**DEPARTMENT OF VETERANS AFFAIRS**  
Nebraska/Western Iowa Health Care System  
4101 Woolworth Avenue  
Omaha NE 68105

Re: Docket 50 - 131

Enclosed you will find two copies of the addition information requested for the renewal of our Facility Operating License R-57. The original has been sent to the Document Control Desk.

A.J. BLOTCKY REACTOR FACILITY

Fig 3-2 REACTOR LABORATORY BASEMENT

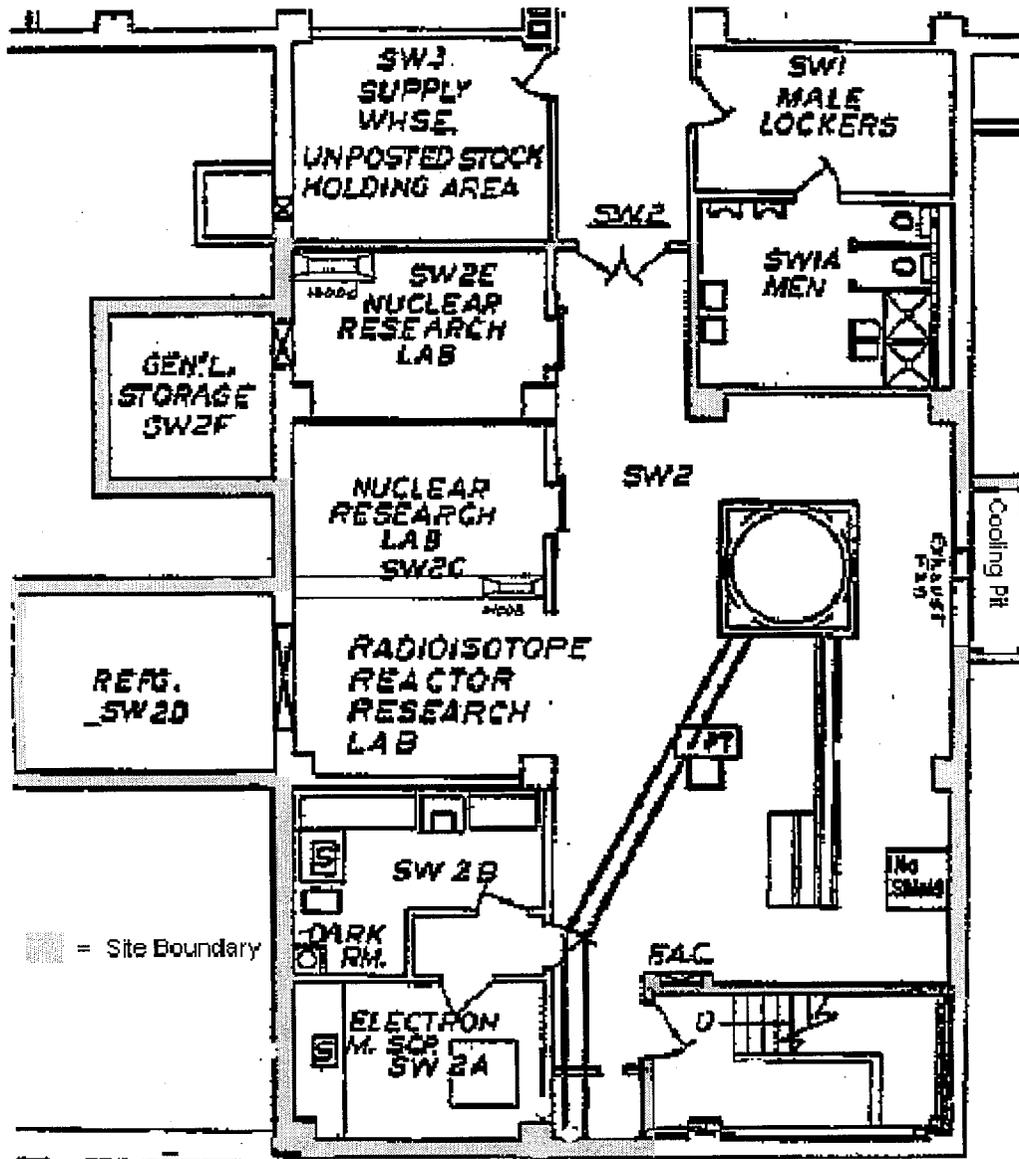
1. **Page 3-3;** Figure 3-2 has been changed to include the refg. SW 2D area within the defined site boundary.
2. **Page 7-3;** Section 7.1.7 has been changed to request 10mCi each of the listed isotopes. Simulated Iodine has been changed to barium – 133.
3. **Page 9-2;** Typographical error changes.
